UNITED STATES PATENT AND TRADEMARK OFFICE

APPLICATION NO.	FILING DATE	FIRST NAMED INVENTOR	ATTORNEY DOCKET NO.	CONFIRMATION NO.
10/655,938	09/05/2003	Yoshihiro Hara	15162/06150	7008
24367	7590	07/09/2004	EXAMINER	
SIDLEY AUSTIN BROWN & WOOD LLP			PERKEY, WILLIAM B	
717 NORTH HARWOOD			ART UNIT	
SUITE 3400			PAPER NUMBER	
DALLAS, TX 75201			2851

Office Action Summary	Application No. 10/655,938	Applicant(s) HARA, YOSHIHIRO	
	Examiner William B. Perkey	Art Unit 2851

DETAILED ACTION

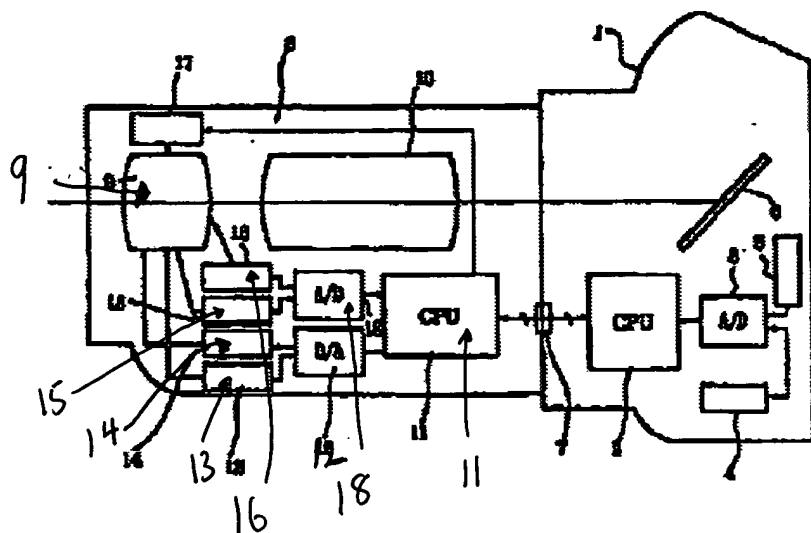
Takayuki discloses a first shake detecting section by elements 15, 18 and 11 in the drawing below reproduced from Takayuki; a second shake detecting section by elements 16, 18 and 11; and a shake correcting section as elements 11, 12, 13, 14 and 9. Takayuki discloses that the sampling period or precision in the pitch direction is double that in the yaw direction. Thus, Takayuki fully meets claims 1-4, 7. The sampling period of Takayuki can be reasonably referred to as a driving frequency of the shake detecting section. Thus, claims 6 and 9 are fully met by Takayuki. Below is the drawing from the reference Takayuki.
